F/CMVSS Noncompliance Recall

45340 BYOM1 Lockup with Loss of Key Chime

Reference Number: A162045340

Revision: 04

4919549

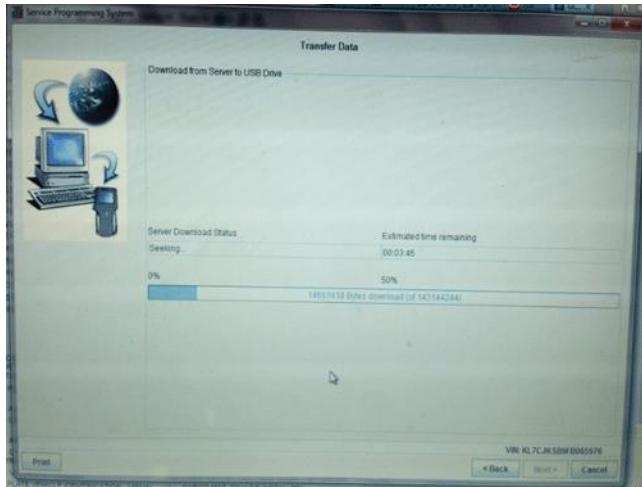
Note: If the Same Calibration/Software Warning is noted on the SPS Controller screen, continue with the programming event using SPS to ensure a Warranty Claim Code is displayed on screen. Technicians MUST record the Warranty Claim Code (1) on the Job Card. To avoid warranty transaction rejection, this information must be entered when submitting the transaction.
